## RESPONSE TO REQUEST FOR ADDITIONAL INFORMATION

### APR1400 Design Certification

Docket No. 52-046

**RAI No.:** 470-8552  
**SRP Section:** 16 – Technical Specifications  
**Application Section:** 16.3.3.1  
**Date of RAI Issue:** 04/26/2016

Figure 7.2-11 **PPS** Testing Overlap

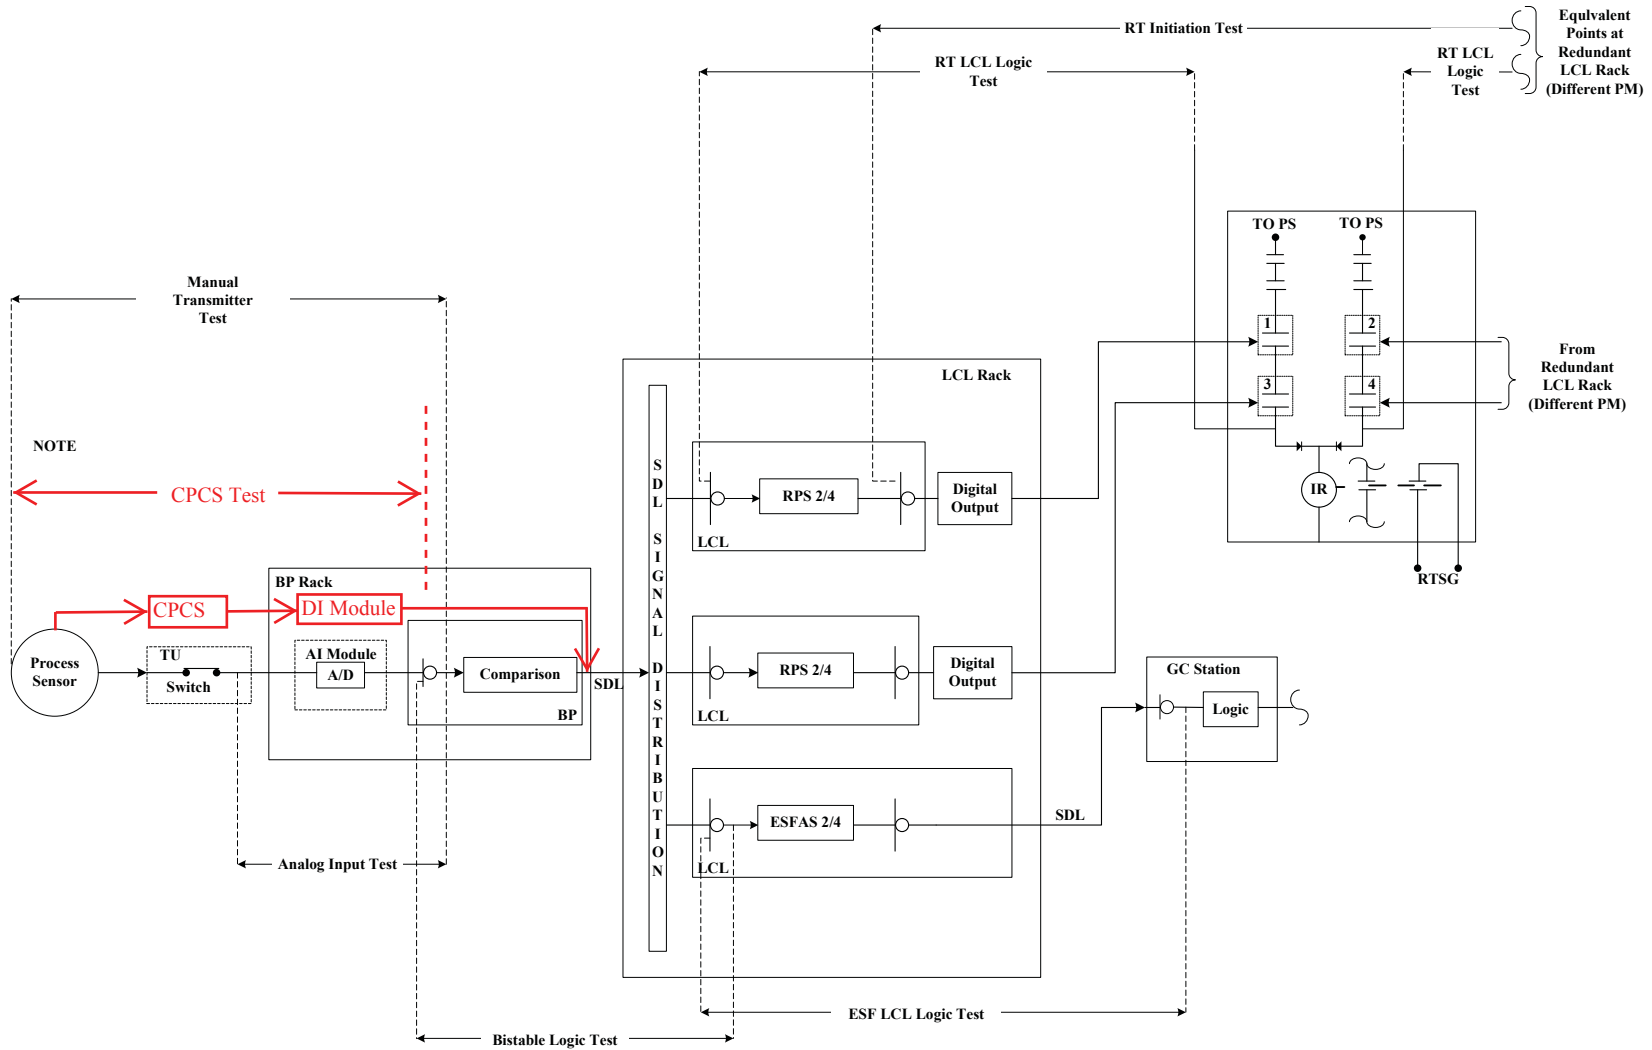
2. Notice that DCD Figure 7.2-11 does not depict "CPCS Test" and "Manual Trip Test", which are described in DCD Section 7.2.2.5. The applicant is requested to revise DCD Tier 2 Section 7.2 so that Section 7.2.2.5 and Figure 7.2-11 are correctly aligned. In addition, consider adding a discussion in DCD Tier 2 Section 7.3 that describes the testing for the ESFAS instrumentation loops with the same level of detail as the requested revised description in DCD Tier 2 Section 7.2.2.5, and also a figure equivalent to Figure 7.2-11. Notice that Figure 7.2-11 depicts no tests for ESFAS related components after the input to the actuation logic in the group controller.

4. The applicant is requested to explain what meaning the "OR" logical gate symbols on Figure 7.2-11 are intended to convey; especially with respect to depicting testing overlap. The requested information is needed to enable the NRC staff to determine whether or not surveillances for RPS and ESFAS instrumentation functions satisfy 10 CFR 50.36 requirements.

1. Table 1 is prepared based on DCD Tier 2 Figure 7.2-11, which shows the testing overlap for the periodic manual tests required to verify the integrity of the RPS functions during power operation of the plant. The component names and descriptions in the figure are identified by relationship with the testing type provided in DCD Tier 2 Section 7.2.2.5, "System Testing and Inoperable Surveillance". Additionally, the "CPCS" and "CPCS test" will be included in DCD Tier 2 Figure 7.2-11.

2. The missing information of CPCS and CPCS Test in DCD Tier 2 Figure 7.2-11 will be added.

4. The logical OR in the receiving stage of bistable processor (BP) indicates that BP logic is processed either by the actual signal or by the test signal. The logical OR in the receiving stage of LCL indicates that local coincidence logic (LCL) logic is processed either by the actual signal or by the test signal.

The logical OR in the transmitting stage of LCL or the receiving stage of the digital output module indicates that the digital output module generates the output either by the actual signal or by the test signal.
